TECH ADVISORY for  
SFI Specification Versions 2.3Q and 2.3P  
Rear Engine Dragster Chassis Structure (Top Fuel); 4.99 Seconds E.T. & Quicker  
Effective: March 17, 2017

Figure 1

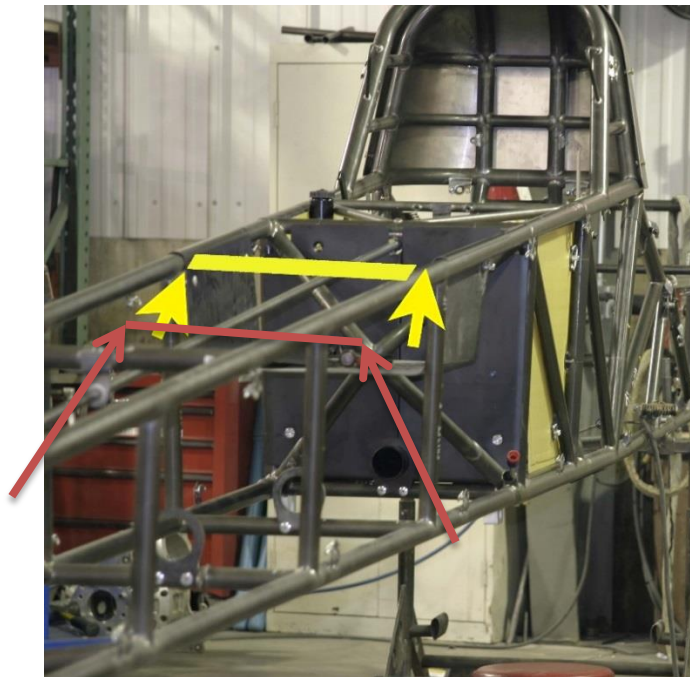
A straight cross member must be placed between the top frame rails, in-line with the first set of uprights past the end of the foot box. This cross member must be bolted or clamped as follows:

- **Tube Requirement:** Minimum  $\frac{3}{4}$ " x .049" round 4130 or Docol R8 or Ti9. Alternately, streamline .049" 4130 tubing with a minimum 1.640" major axis and a minimum 0.714" minor axis may be used. The tubing must be straight.
- **Mounting:** Minimum  $\frac{5}{16}$ " rod end / spade, and  $\frac{5}{16}$ " bolt per end. Rod end / spade must be in double shear between 2 tabs. If clamped, there must be two clamps per end.
- **Position:** The cross member must be in-line with the 1st set of uprights, and mounted to either the upper frame rails or the uprights (yellow line in figure 1). If mounted to the uprights the cross member's center must be no lower than 2.50" from the centerline of the upper frame rail (Figure 2).

**Additionally:** If the chassis does not have an existing cross member in line with second set of uprights past the end of the foot box (red line in Figure 1), an additional straight cross member meeting the above requirements must be installed in that position.
